## Technical Bulletin #1660

**Subject:** Erratic Shift Concerns, Solenoid Performance Codes and Erratic TCC Operation

## Technical Bulletin #1661

## Technical Bulletin #1662

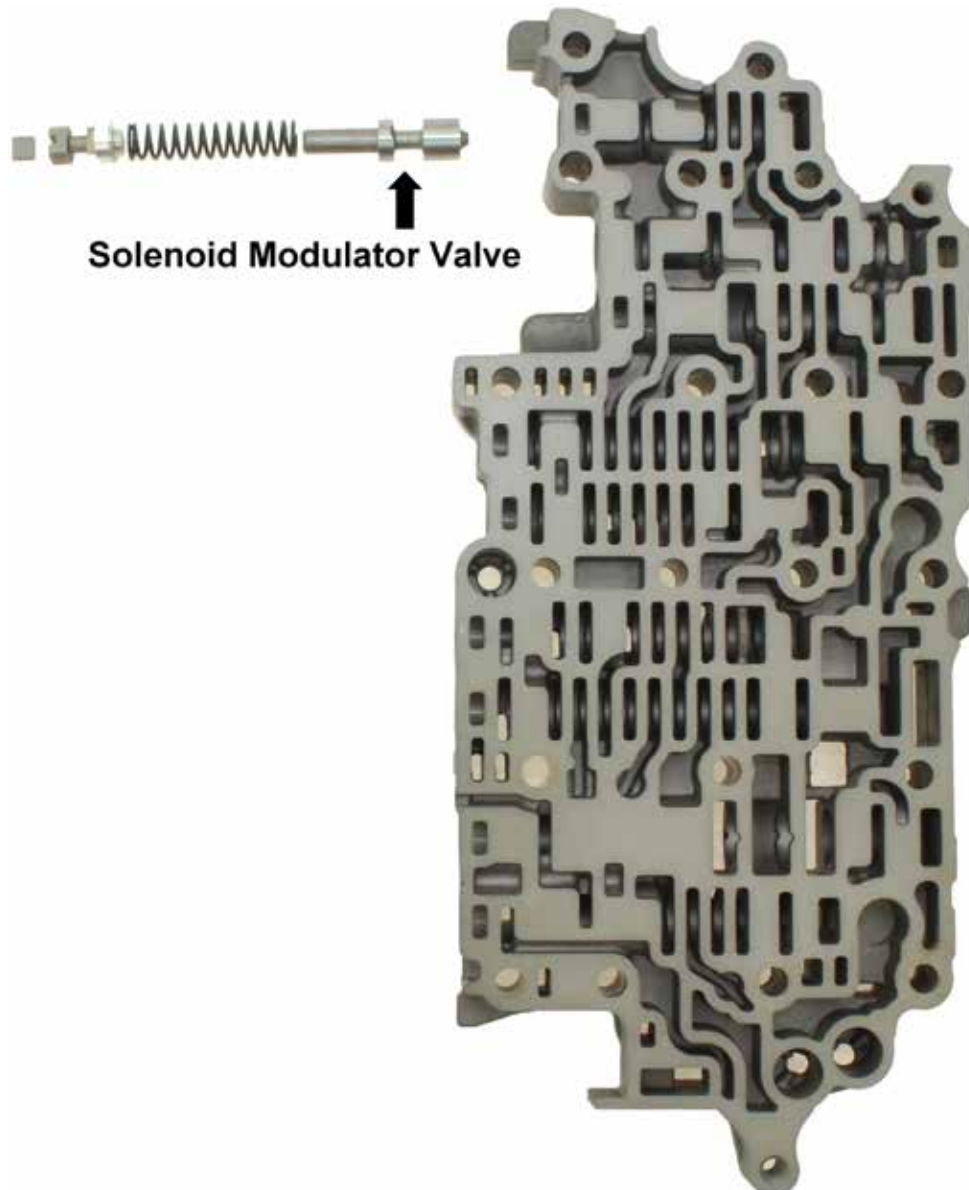
While working on a U650E, U660F, U760E or a U760F transmission, you may encounter erratic shift concerns, solenoid performance codes or erratic TCC operation. These concerns may be caused by a worn solenoid modulator valve and bore. Replacing the solenoid modulator valve and repairing the bore may be needed to repair this concern.

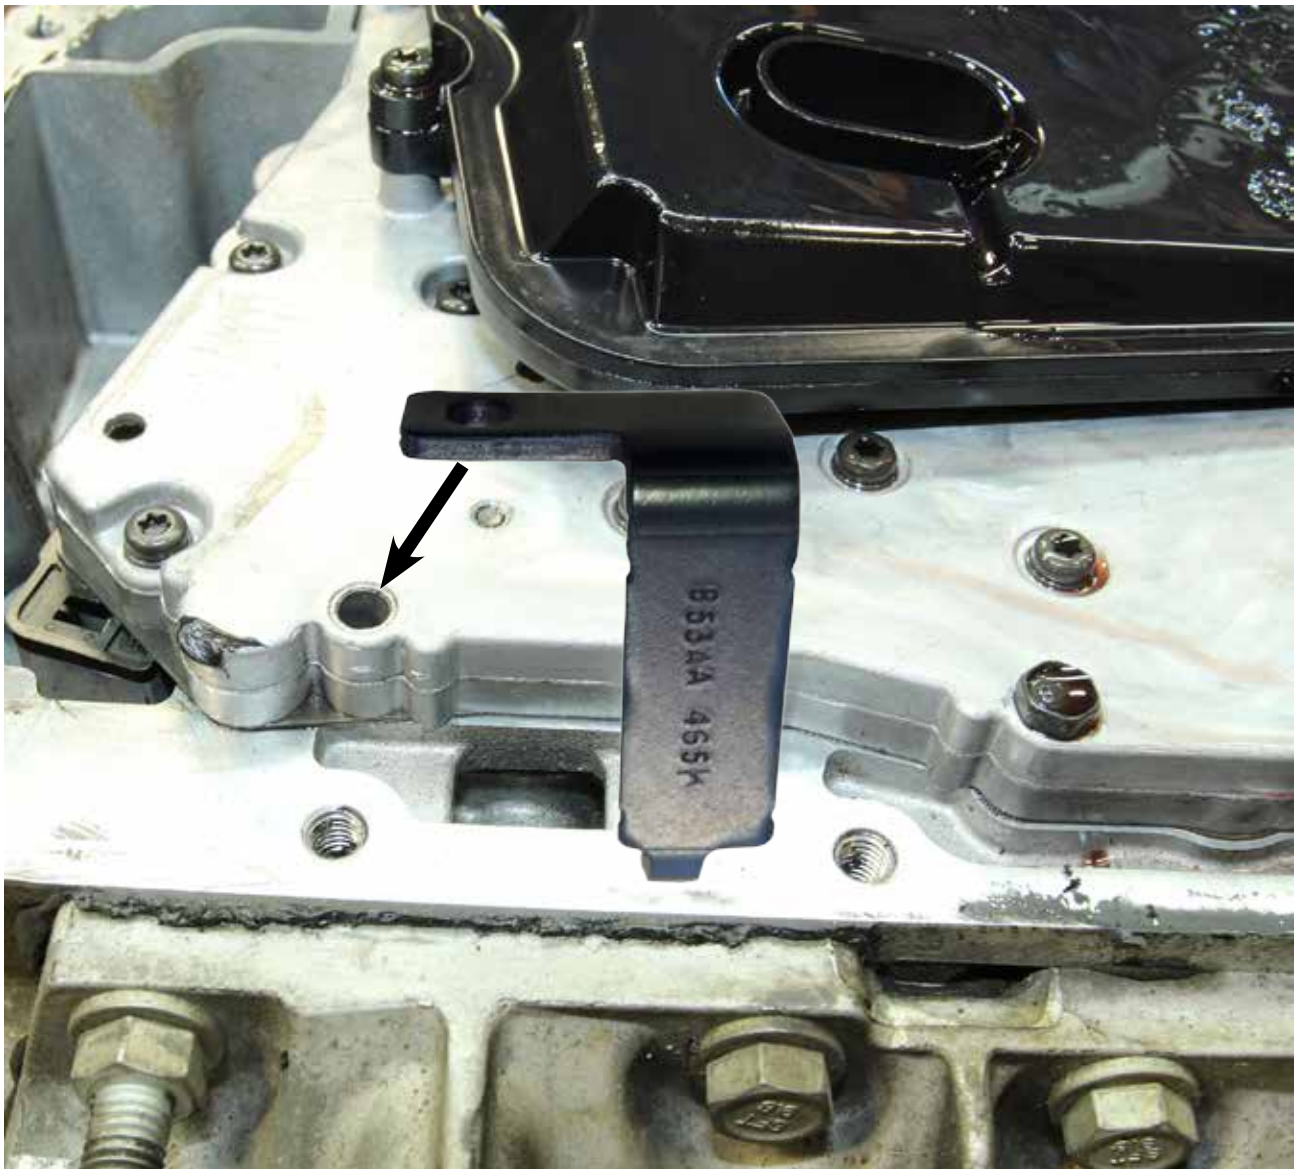
If you ever see this part in your parts basket and ask yourself if it belongs to your transmission, the answer is yes. This is a bracket that is used as a retainer for the parking pawl anchor pin in the rear of the case. It bolts onto the valve body at this location (see figure).

Figure 1

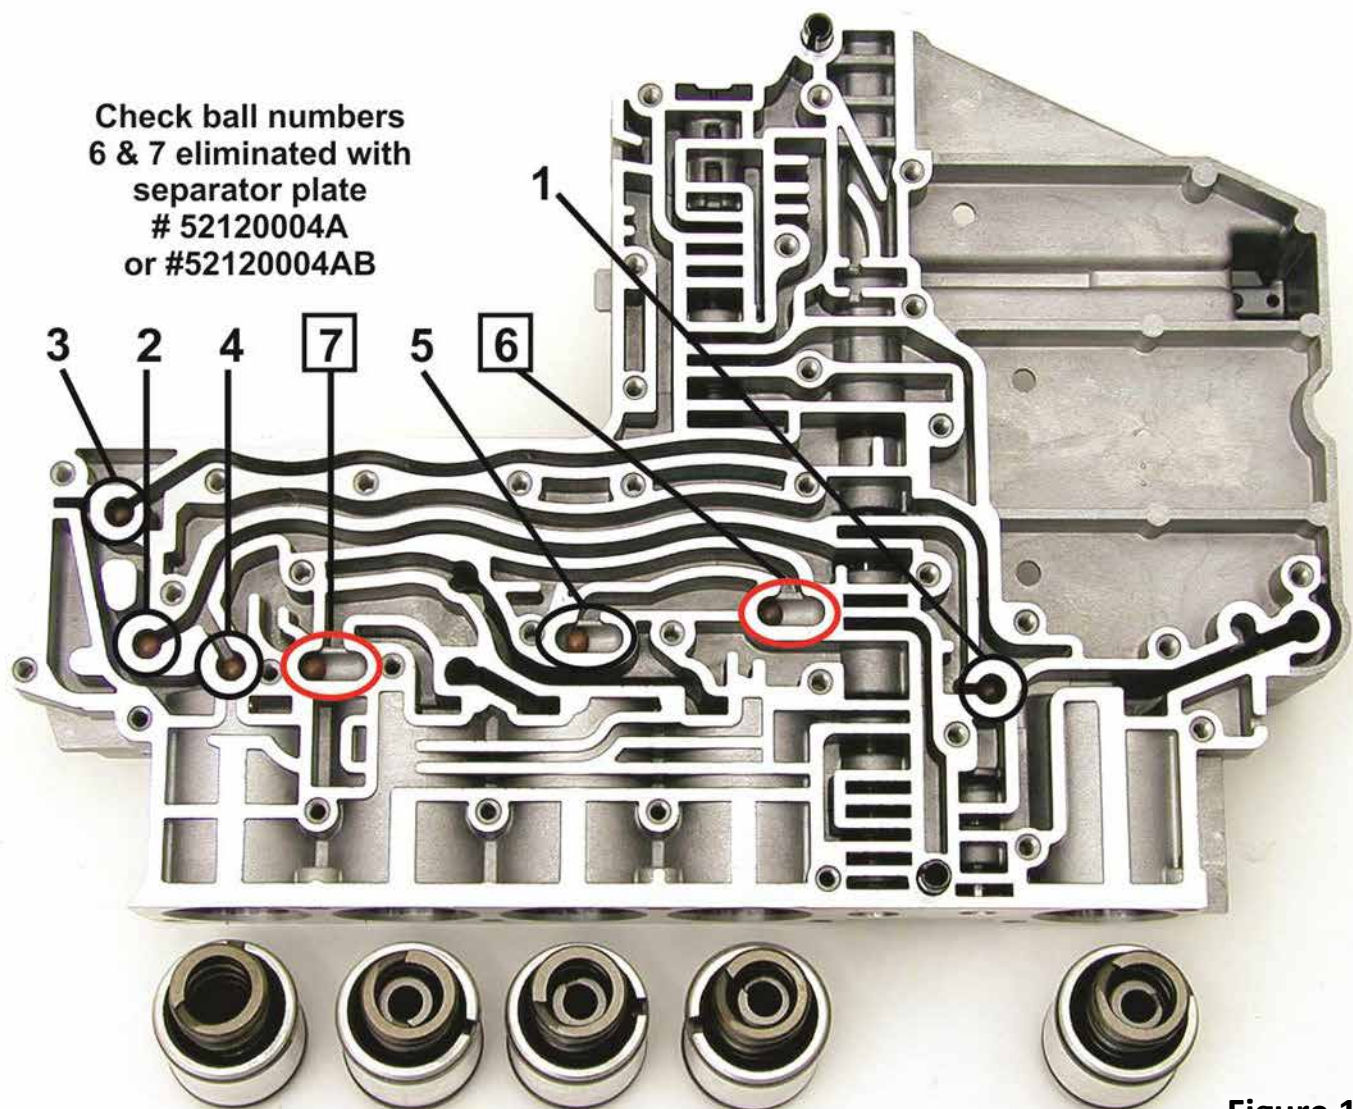
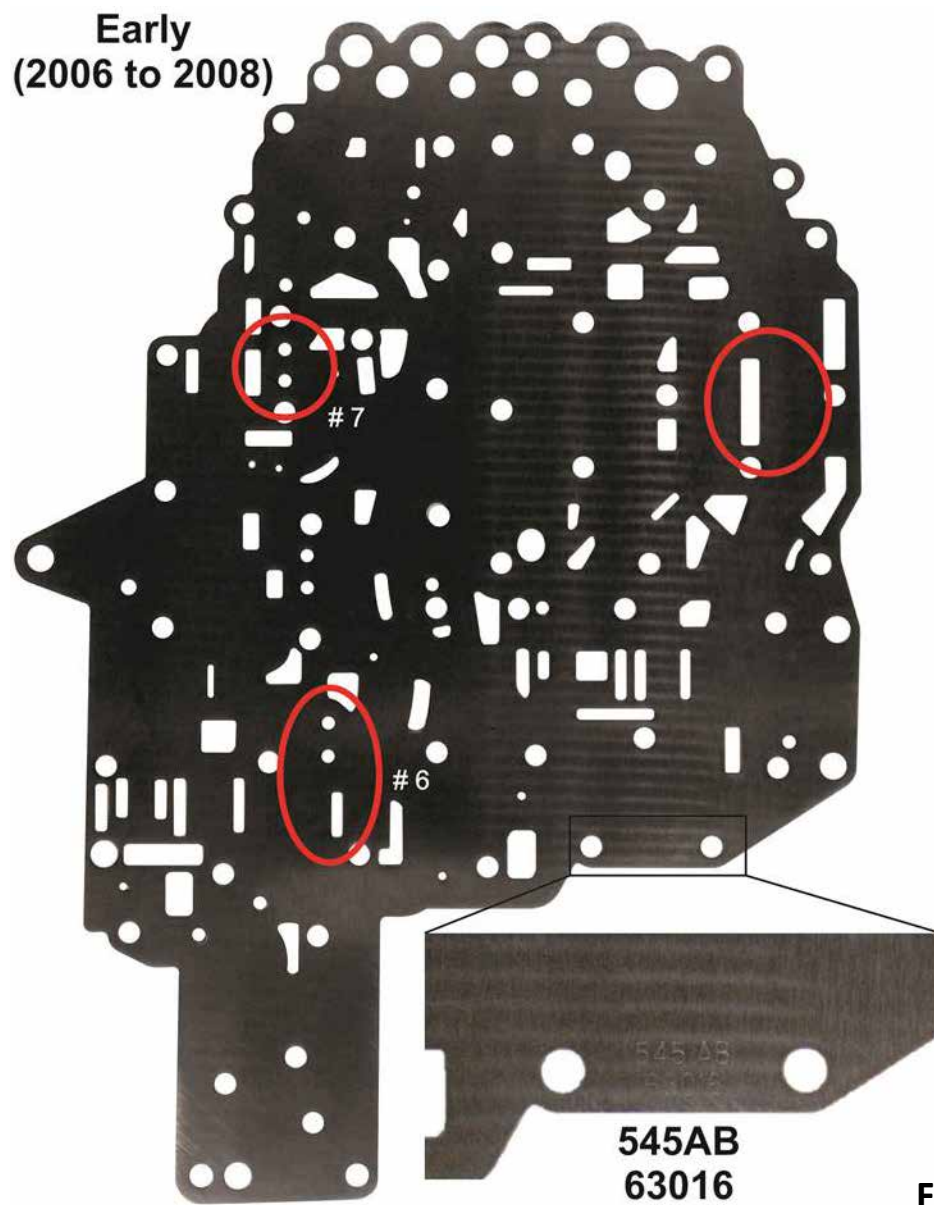
The O/D solenoid was eliminated and the hydraulics changed in 2009 model year. Along with these changes the separator plate changed and the #6 and #7 check balls were eliminated.

The 2006-to-2008 valve body separator plate (part number 545AB) is shown in figure 1. The 2009-and-later separator plate (part number 52120004A;) (figure 2) identifies the feed holes that were eliminated over check ball #6 and #7 locations.

**Figure 3**

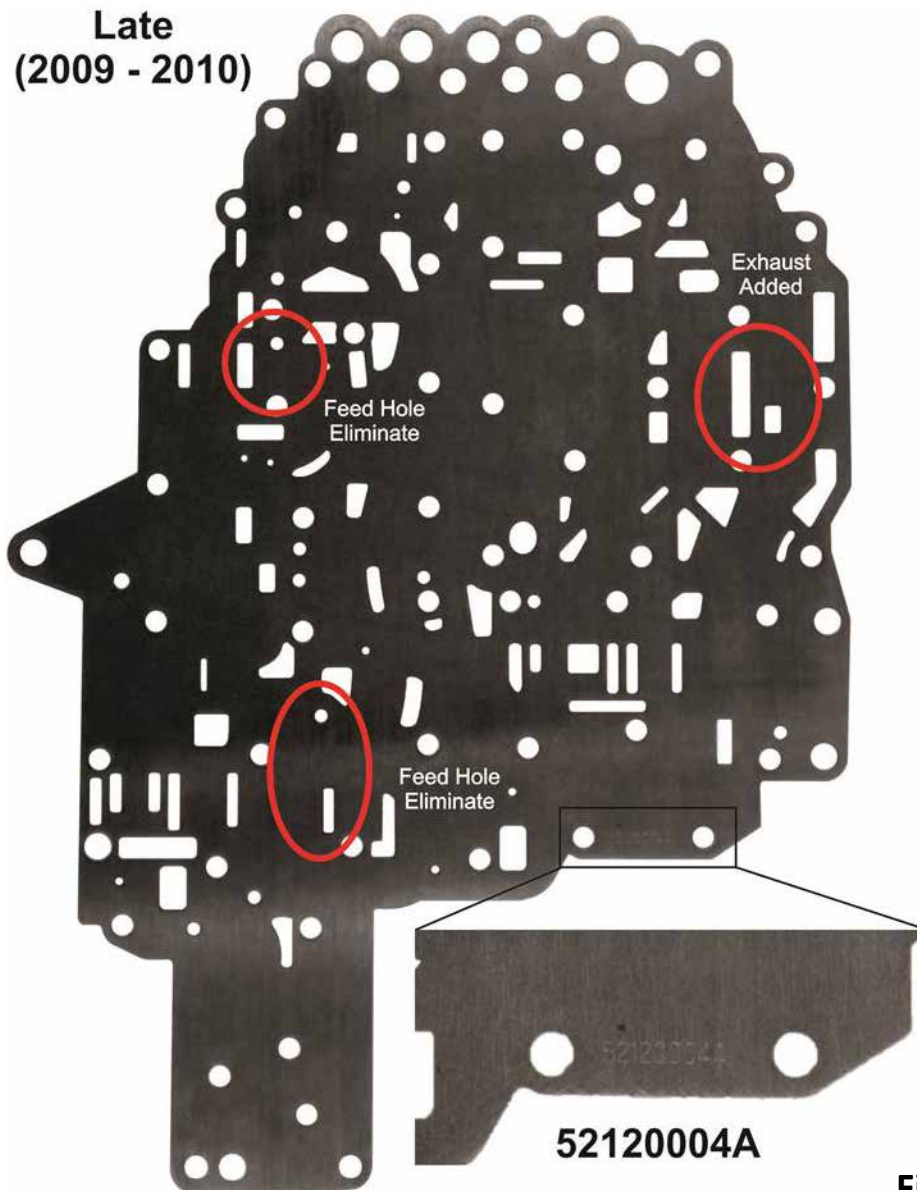
Checkball #6 was removed to allow the multi select solenoid to control overdrive clutch apply instead of the overdrive solenoid. This eliminated the need for the overdrive solenoid (figure 3).

Check ball #7 was removed to allow the 2C solenoid to control the 2C clutch apply in the manual 2 range instead of the multi select solenoid (figure 3).

**Figure 1**

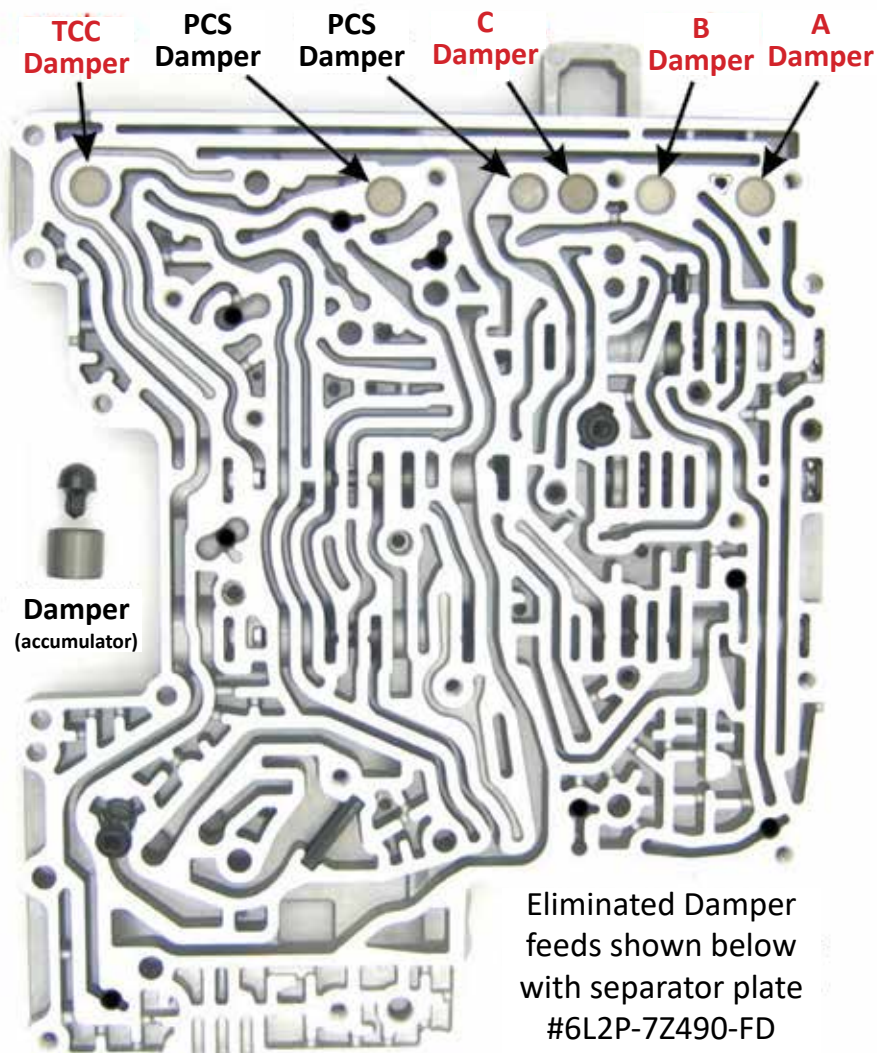
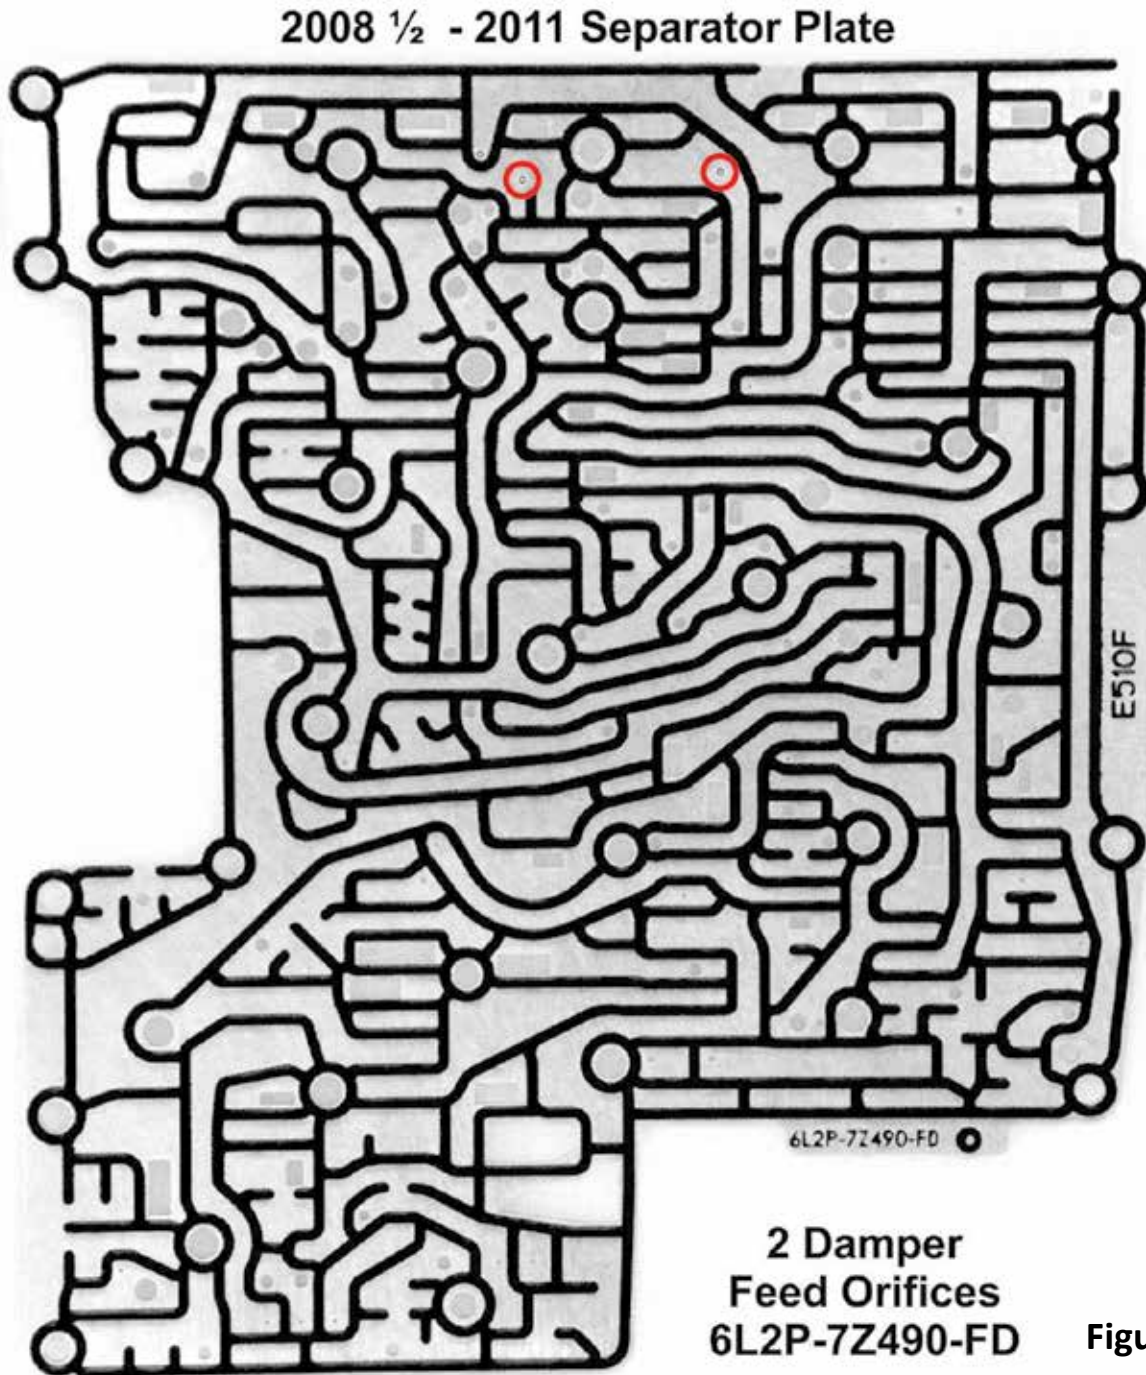
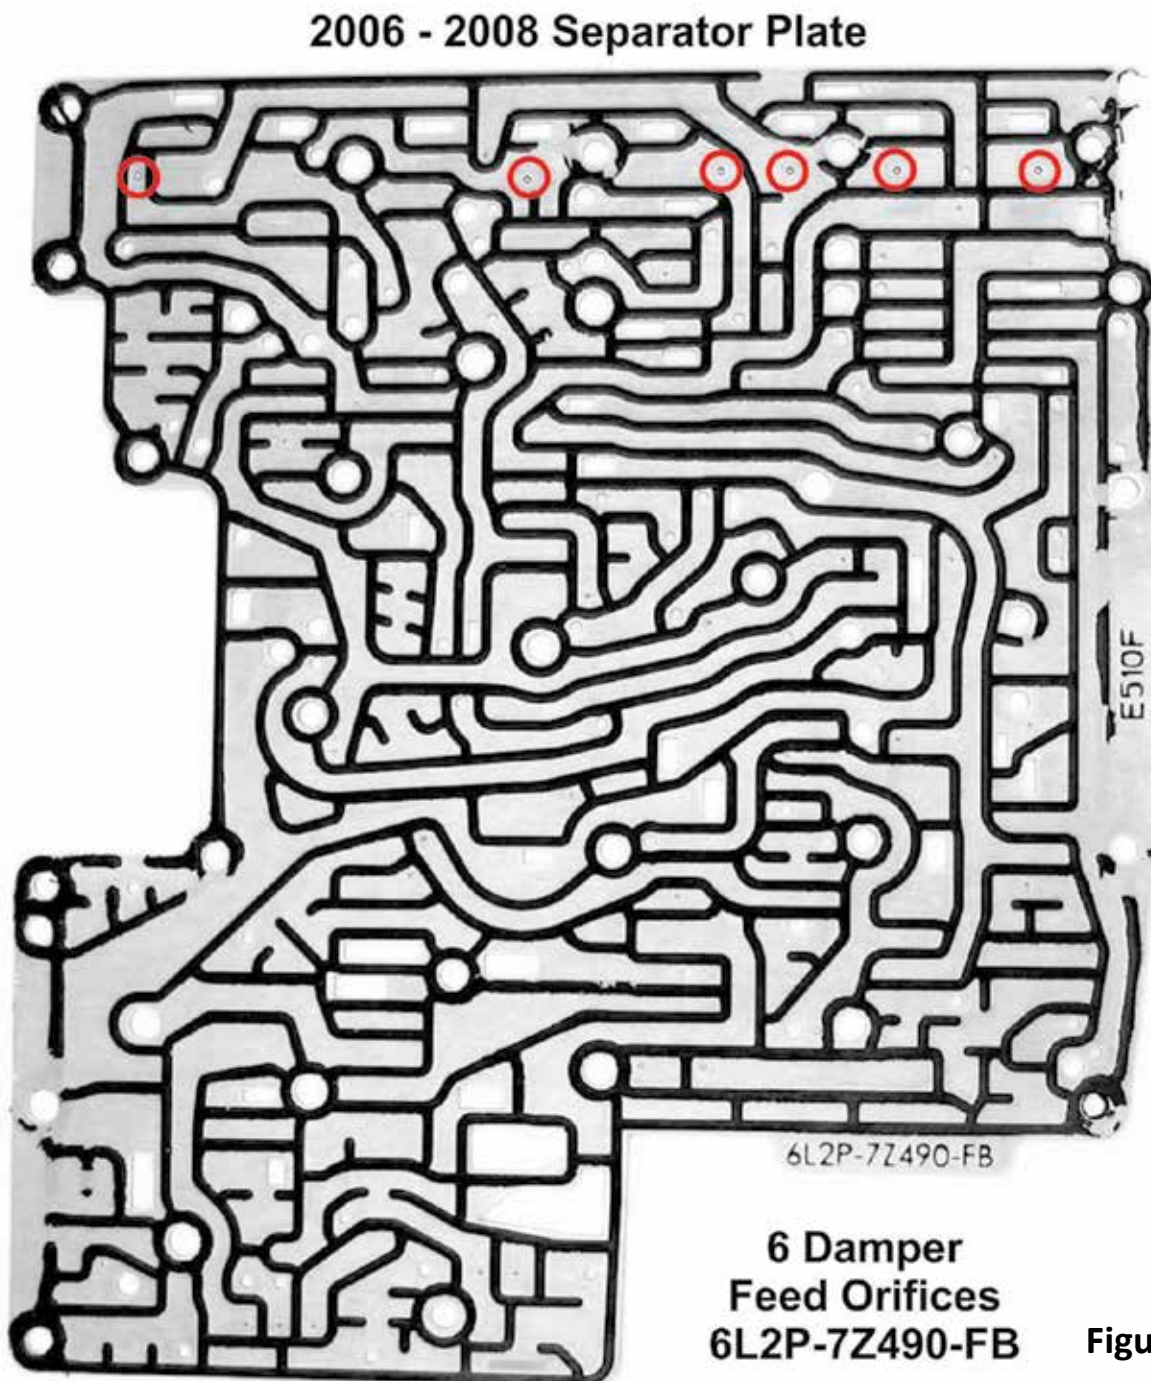
The 6R60, 6R75 and 6R80 are referred to as TCM Driven units, initially released with Bosch solenoids and six dampers (accumulators) for the 6R60 and 6R75 transmissions until 2008 ½ or J1 units. In 2008 ½ (11/16/09 J2 units) during testing Ford learned that only two were required so they eliminated four dampers; A,B,C and TCC (figure 1) along with the feed holes in the separator plate part #6L2P-7Z490-FD (figure 2). The D1 regulator spring bore 201 was removed and added a bleed circuit to the “D” clutch these vehicle required using MERCON SP oil. The ID number on the 2006 to 2008 separator plate is 6L2P-7Z490-FB (figure 3).

If you get one of these plates in a rebuild kit and it does not match the one that came out of the vehicle the holes should be drilled to match the original one. These plates are calibrated to the year make and model designation.
